**Consolidated COMMENTS for the Draft UAT MOPS
RTCA Paper No. 132-02/SC186-196**

Proposed Addendum to Appendix M

**Proposed Change to Appendix K
File “surface.doc”**

Proposed Change to Appendix K

Figure K-122: A0 Receiver on the Surface in LA2020 Scenario Receiving A3 Transmitters

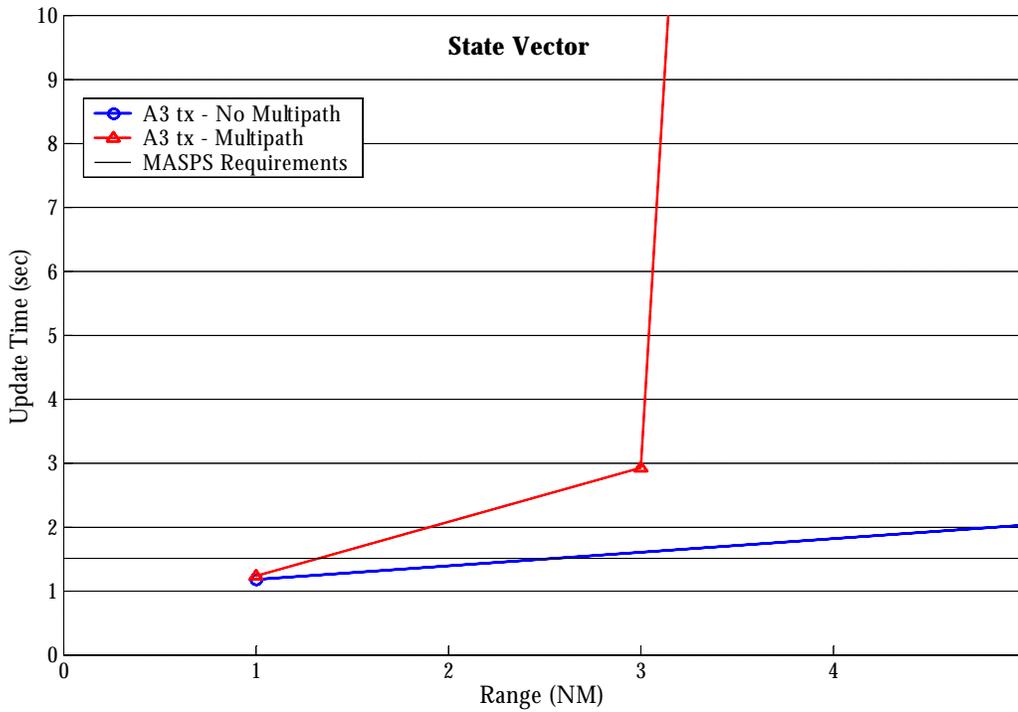
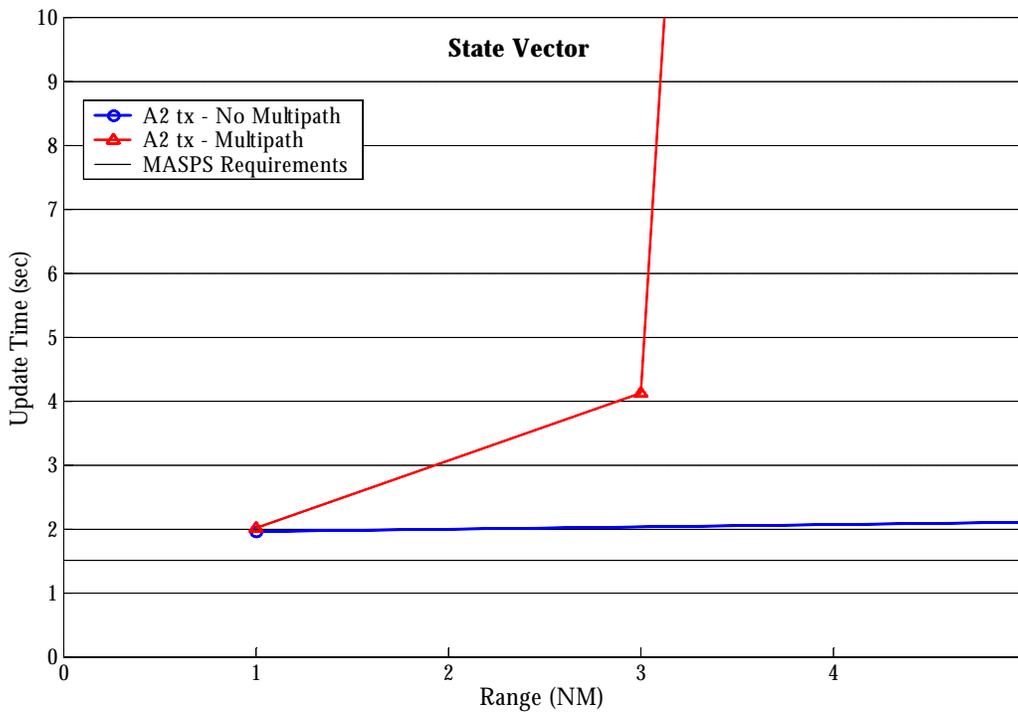
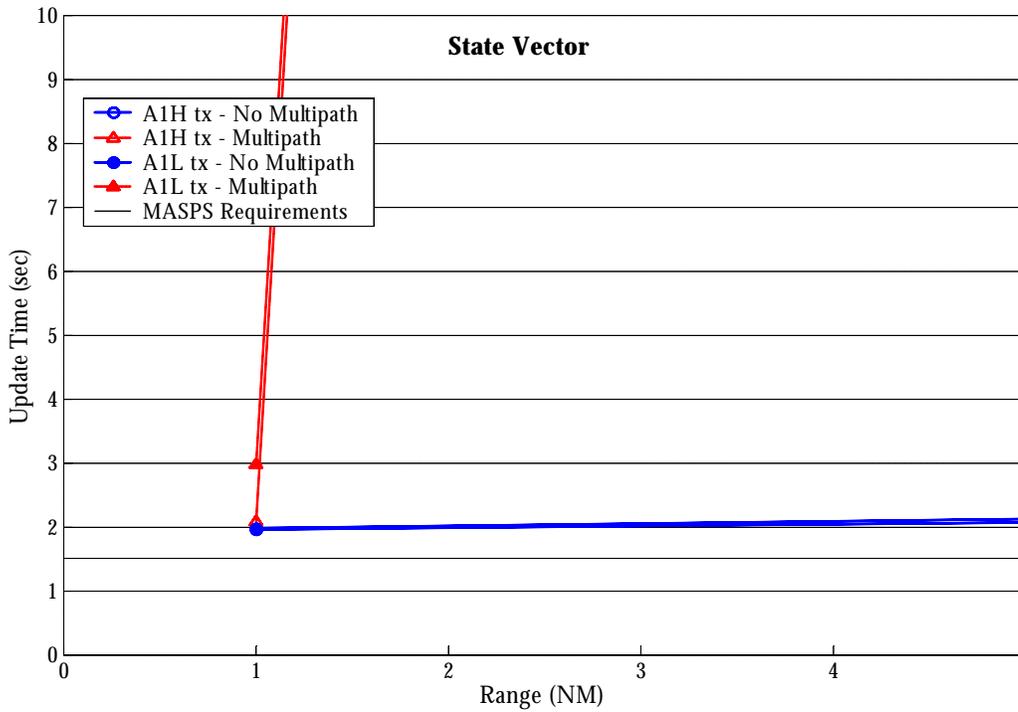
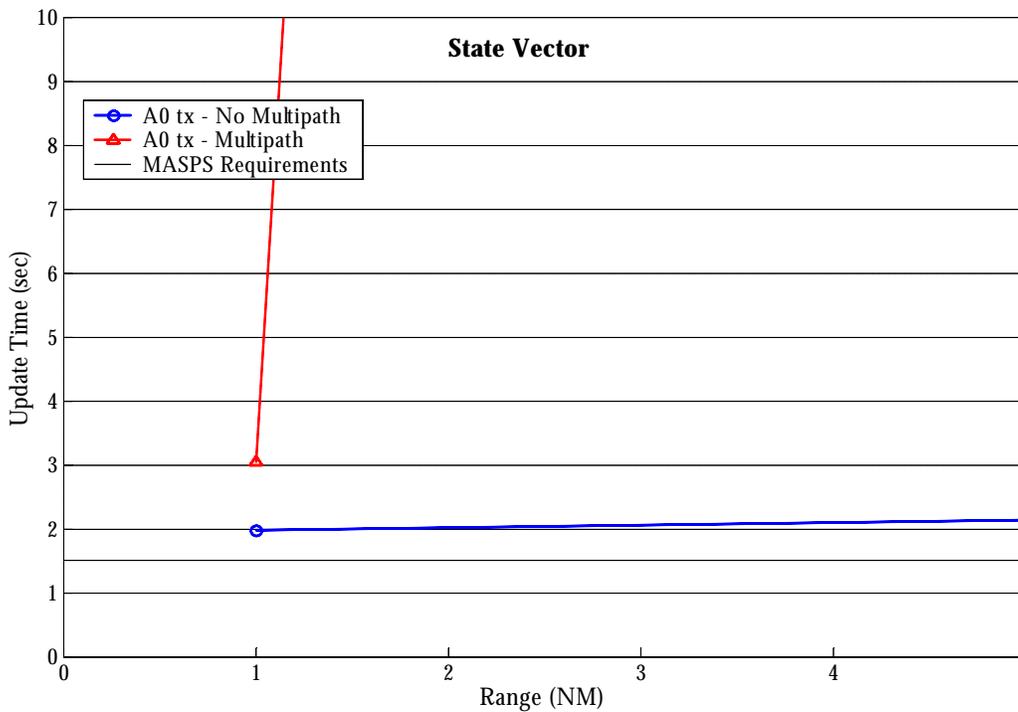
#	Author	Section	Page	Comment	Suggested Resolution
5	JHU-APL	K.4.5	K-76	Section K.4.5 results and conclusions do not correspond to requirements on surface	<p>Replace text after first three paragraphs of K.4.5 with attached document “surface.doc”, which updates Figures 110-125 and conclusions</p> <p>WG-5 Response: Attached document inserted with summary having been modified from the original. Done</p>
6	JHU-APL	K.4.6 (addition to current K.4)	?	In accordance with Table G-6, Overview of Scenario Assessments, no results for an A0 receiver on the surface receiving aircraft on approach at 2000’ altitude are shown	<p>a) Insert a new section K.4.6 with attached document “A0 on Ground.doc”</p> <p>b) Change name of current Figure K-126 to Figure K-128 to reflect new inserted section</p> <p>c) Add the following sentence at the end of the 4th paragraph of K.1.1: “Section K.4.6 presents the results for a A0 receiver on the surface receiving aircraft on approach.”</p> <p>d) Delete the 2nd paragraph under paragraph K.4.5</p> <p>WG-5 Response: Attached document inserted having been modified from the original. Done</p>

Replace text after first three paragraphs of K.4.5 with this document, which updates Figures 110-125 and conclusions

The results for the aircraft-to-aircraft surface-to-surface performance from Figures K-110 through K-125 may be summarized as follows:

- For the bounding cases with no multipath and with worst-case elevation plane multipath, the 95th percentile surface update requirement for the ADS-B MASPS (1.5 seconds out to 5 NM) are met for A3 transmitters up to 1-2 NM away.

- The 95th percentile surface update requirement for the ADS-B MASPS (1.5 seconds out to 5 NM) are not met for all other cases on the surface.
- The 95th percentile update time on the surface for all aircraft classes to 5 NM for the bounding case of no multipath is approximately 2 seconds. A3 transmitters can be seen by A2 and A3 receivers out to 5 NM with, approximately, a 3 second 95th percentile update time. A2 transmitters can be seen by A2 and A3 receivers out to 5 NM with, approximately, a 5 second 95th percentile update time.

- The 95th percentile update time on the surface for all aircraft classes for the bounding case of worst-case multipath is approximately 3 seconds at a range of 1 NM. The limiting factor at ranges greater than 1 NM is the transmit power and antenna placement for A0 and A1L class equipment, combined with the effect of 175 interferers at close range.

Figure K-126: A0 Receivers on the Ground in LA2020 Receiving All Aircraft on Approach at an Altitude of 2000 feet

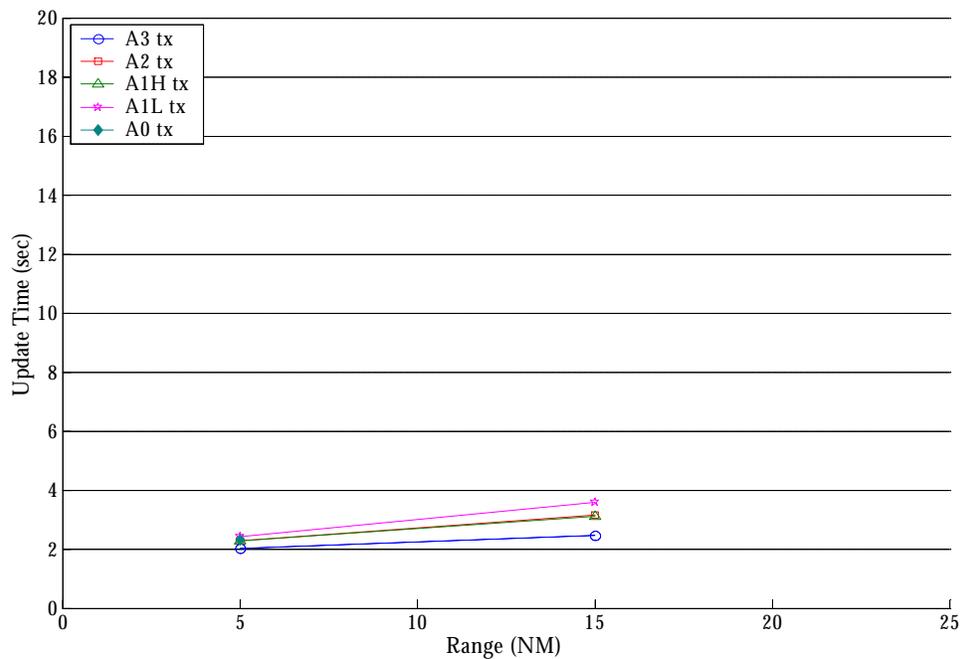
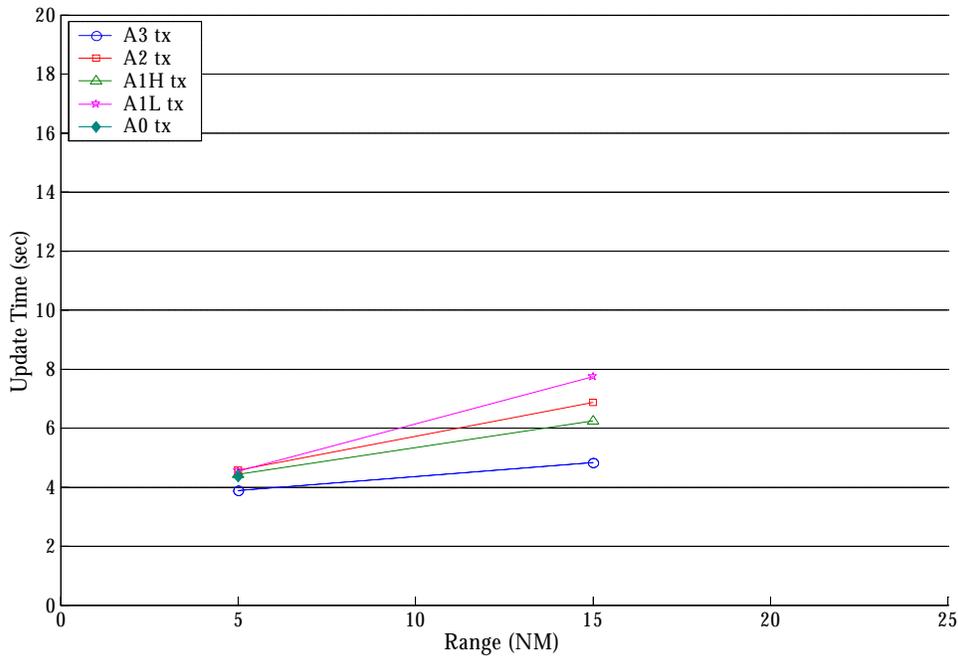
- e) Insert this document, which comprises a new section (K.4.6)
 - f) Change name of current Figure K-126 to Figure K-128 to reflect new figure numbering
 - g) Add the following sentence at the end of the 4th paragraph of K.1.1: “Section K.4.6 presents the results for a receiver on the surface receiving transmissions from aircraft on approach.”
-

The results for an aircraft on the surface receiving aircraft on approach are shown in Figures K-126 and K-127. We know of no specific ADS-B MASPS requirements for this situation.
